# Chip Errata for the MPC7410

The MPC7410 is a PowerPC™ microprocessor. This document details all known silicon errata for the MPC7410 and its derivatives. [Table 1](#) provides a revision history for this chip errata document.

**Figure 1-2. PLL Power Supply Filter Circuit Work Around**

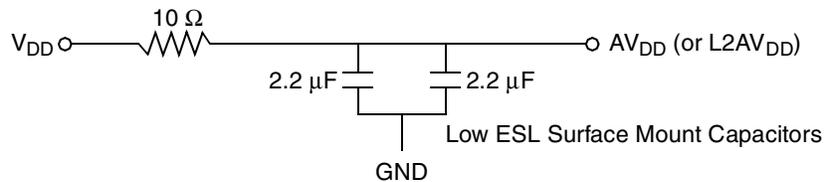
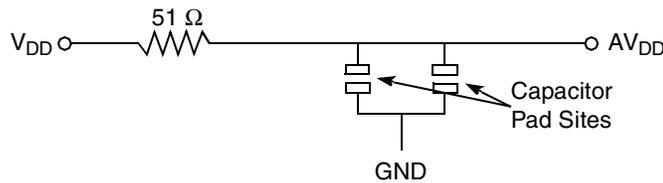
On systems that implement the PLL filter at the  $AV_{DD}$  input pin (as shown in [Figure 1-1](#)), if the system exhibits a high amount of noise on  $OV_{DD}$ , it is possible for the noise on  $OV_{DD}$  to couple into the PLL supply voltage ( $AV_{DD}$ ) internal to the MPC7410 microprocessor through the CBGA package. This issue is unique only to the  $AV_{DD}$  input of the MPC7410 CBGA package and is more likely at high system bus frequency and heavy bus traffic, that is, high likelihood of worst case I/O buffer switching. Note that this error has no impact on the  $L2AV_{DD}$  input of the MPC7410. System designs should still implement the filter shown in [Figure 1-1](#) on the  $L2AV_{DD}$  input.

This error has been seen on very few customer systems. Measurements on those systems show system errors coincident with noise measurements at the  $AV_{DD}$  pin around 500 mV peak-to-peak (600 mV max) with the original  $AV_{DD}$  filter while running heavy system and L2 bus traffic. With the new filter, noise at the  $AV_{DD}$  pin increased to around 800 mV. This  $AV_{DD}$  noise was not visible on the  $V_{DD}$  side of the  $AV_{DD}$  filter circuit.

The recommended  $AV_{DD}$  filter, shown in [Figure 1-1](#), was designed to keep high-frequency noise from entering the chip from the  $V_{DD}$  supply but actually works against suppressing the high frequency  $OV_{DD}$  noise coupled onto  $AV_{DD}$  internally. By depopulating the filter capacitors, the external supply can meet the instantaneous current requirements of the PLL circuitry and improve noise margin. If the filter capacitors are depopulated, the series resistor should be increased to 51  $\Omega$ . This increased resistance provides better damping for the inevitable inductance in the  $AV_{DD}$  path from board to package to silicon.

It is the recommendation of Freescale that systems that exhibit a high amount of noise on  $OV_{DD}$  implement the  $AV_{DD}$  filter fix shown in Figure 1-2. Both filter options should be qualified by the customer, and the solution providing the most robust margin should be implemented. It is also recommended that the pads for the removed capacitors be left in the design to provide for the possible re-introduction of the filter in Figure 1-1. This would be necessary in order to migrate between the two filters, or in the case that there is a planned transition to the HCTE package of the MPC7410. Designs using the HCTE package of the MPC7410 should implement the filter shown in Figure 1-1.

Implement the  $AV_{DD}$  filter shown in Figure 1-2.
